Planning statement in support of an  
application to vary condition 3 of  
planning permission 2013/6388/P

Kings College Court  
55 Primrose Hill Road  
London  
NW3 3EA

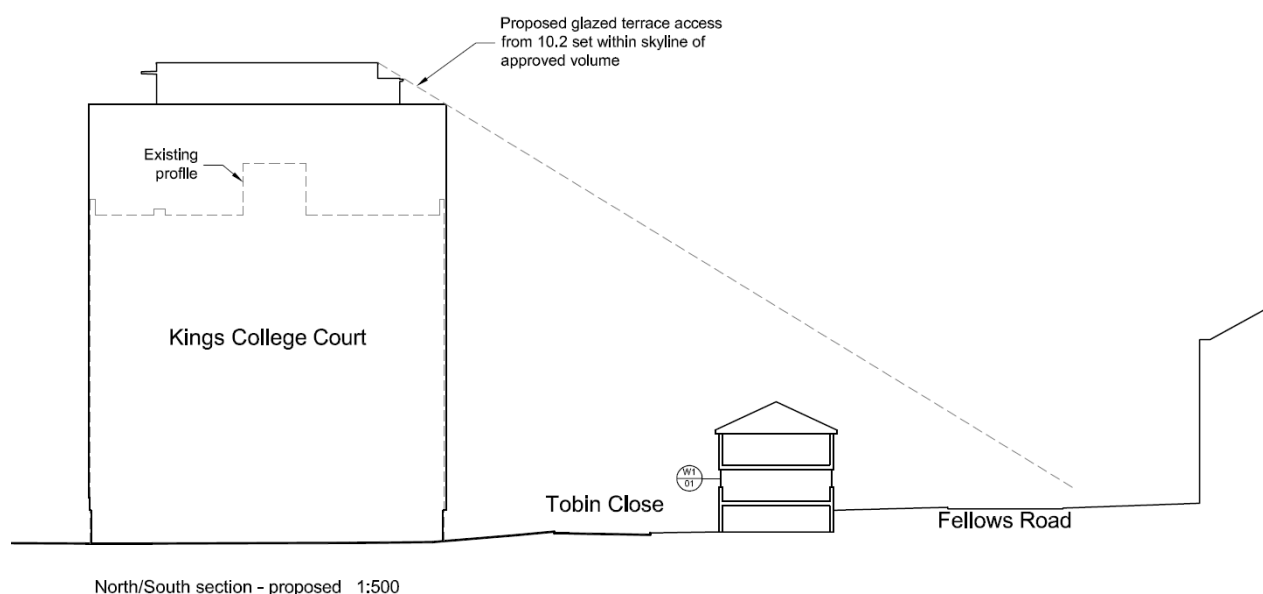
### 1. 11<sup>TH</sup> FLOOR TERRACE FOR FLAT 10.2

On the approved scheme, there is a large area of flat roof on the 11<sup>th</sup> floor which was underutilised. It is therefore proposed to bring this into beneficial use as an additional terrace for Flat 10.2 This requires the introduction of a small glazed lobby to the north side of the Belvedere (11<sup>th</sup> floor) to allow access to the terraced area. The lobby has been sized so that it sits within the skyline of approved belvedere structure and as such has no impact on sun or daylighting to neighbouring properties, as the section below:

There is no material increase in overlooking of neighbouring properties.

Extract from approved drawing 0903/1100/P3

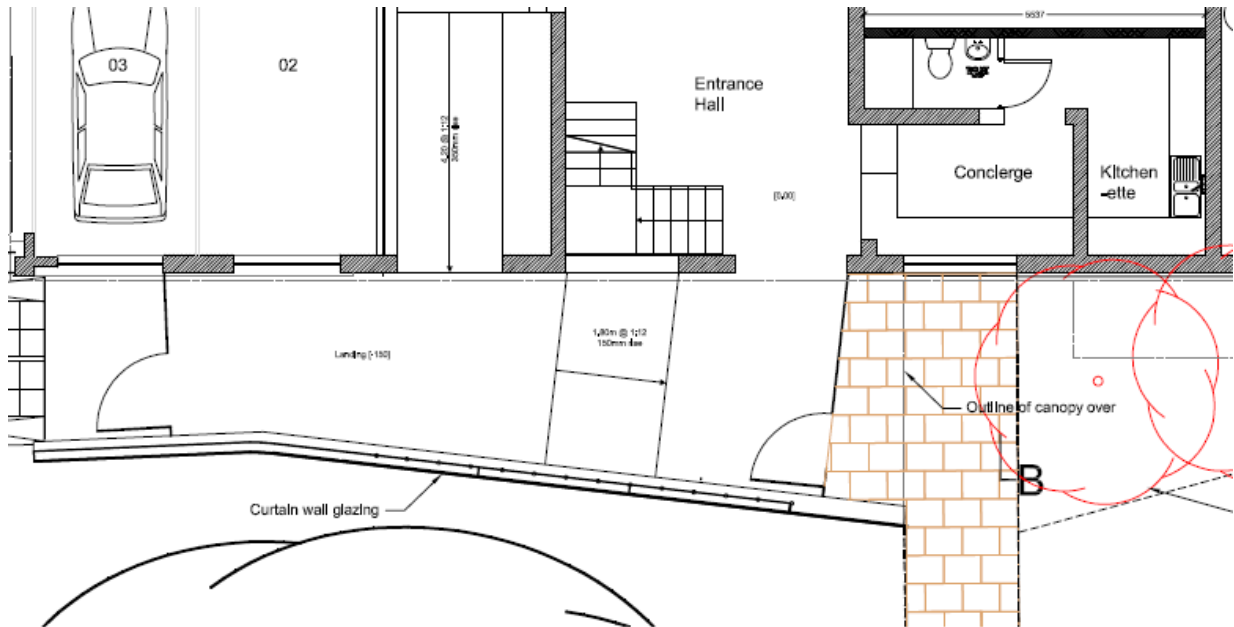
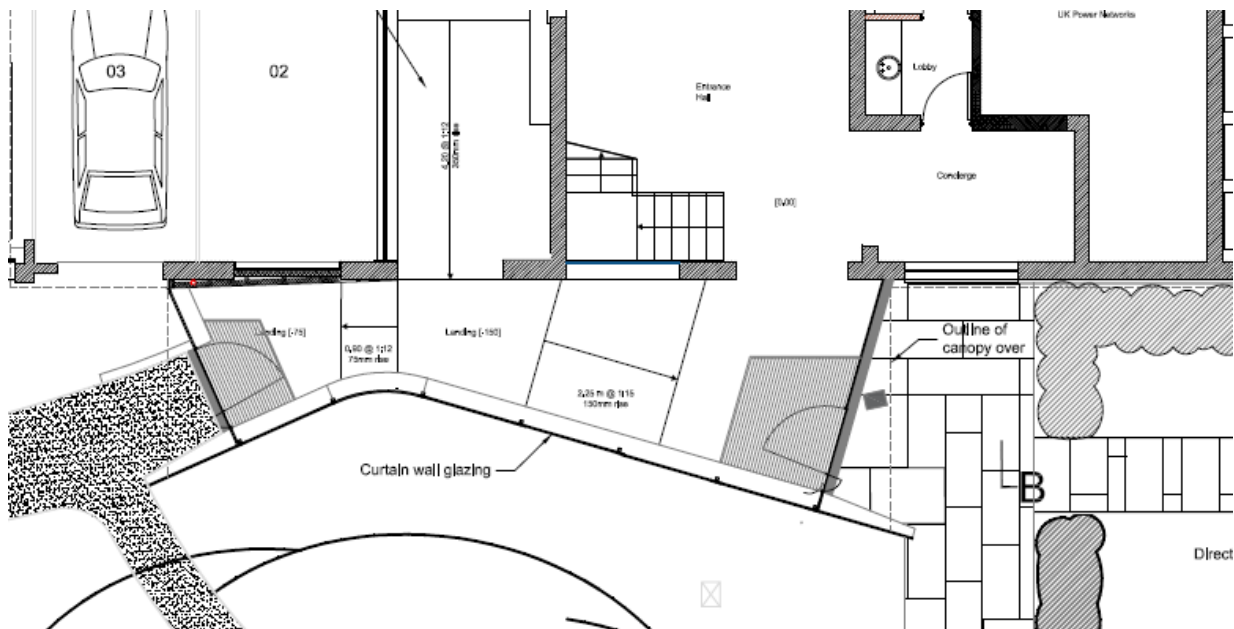
## 2. GROUND FLOOR VESTIBULE

This element has been refined as part of the detailed design and now has a more “waisted” plan form which makes it more elegant than the original design. This is exemplified by the curved double glazed unit which celebrates the curtain wall glazing as a single sweeping element. The gentle pitch to the roof better distinguishes the main entrance over the rear secondary entrance.

### 3. ACCESS

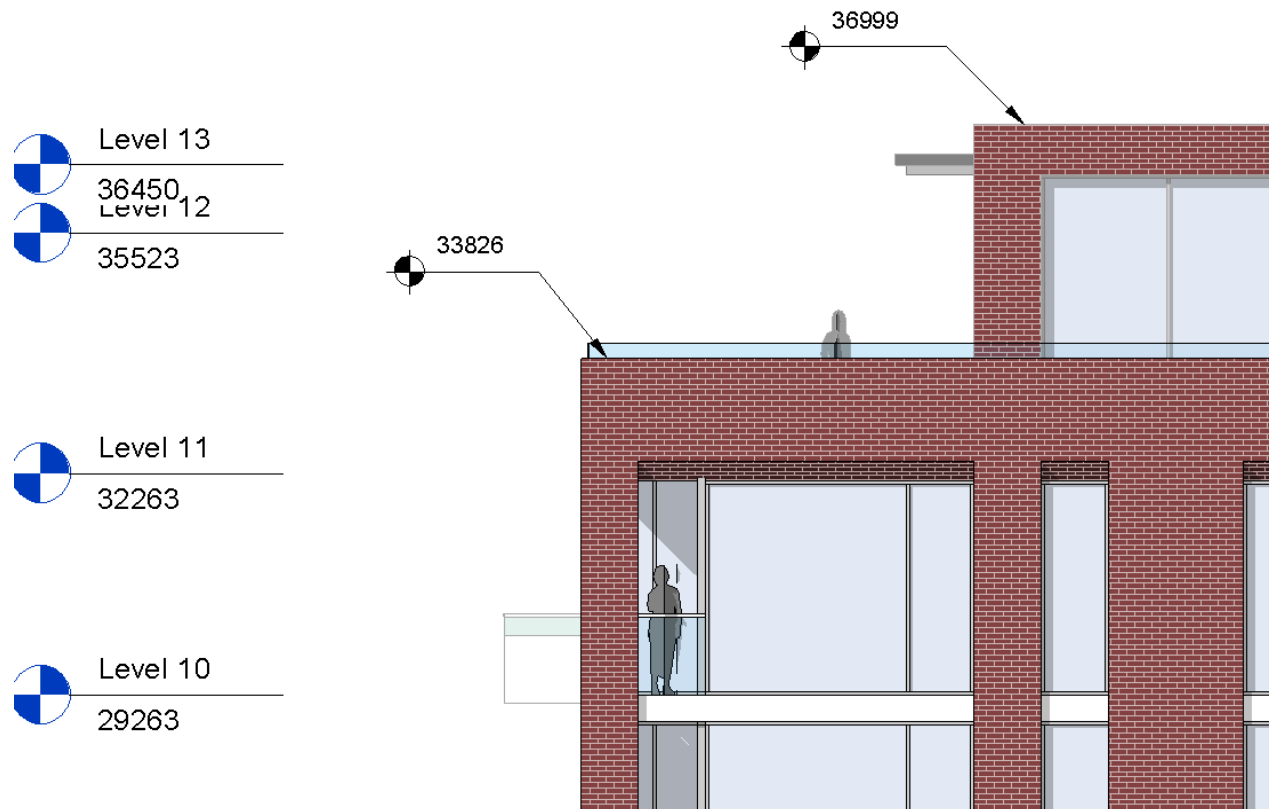
On advice from London Fire Brigade, we have removed the ramped access from the north as this involved changing the internal fire escape arrangements. To provide level access from the 2 parking spaces for disabled, a level path has therefore been introduced leading directly to the main entrance.
